Product Change Notification

105852 - 00

Change Notification #: 105852 - 00
Change Title: Intel® PXA271 and PXA272, LVPXA27xF and RVPXA27xF Processor Family, PCN 105852-00, FYI, JEDEC Tray Pocket Redesign
Date of Publication: January 27, 2006

Revised 14x14mm JEDEC Tray

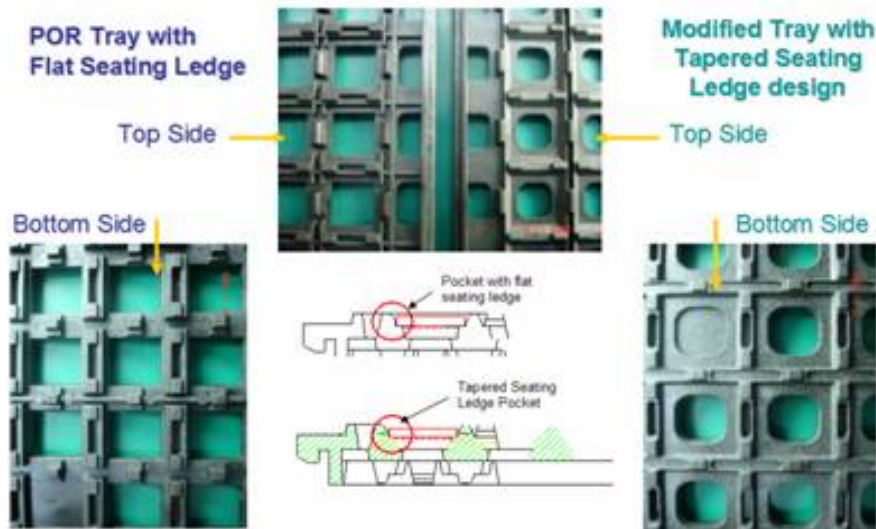
Intel will be implementing a new 14x14mm JEDEC tray pocket design to minimize the chance of trace cracking during shipment. A new tapered seating pocket replaces the existing flat seating pocket.

All Intel® PXA271 and PXA272 Processor Family products (FS-CSP) will ship in the new tapered seating pocket tray.

Post conversion material (redesigned taper seating pocket trays) is not compatible with pre-conversion material (flat seating pocket trays), i.e. the old & new trays are not stackable to prevent mixing.

This change does not impact Customer's equipment set-ups or overall material processing. There is no change to the total number of pieces each tray can hold, or to the number of trays each shipping container (packaging) can hold.
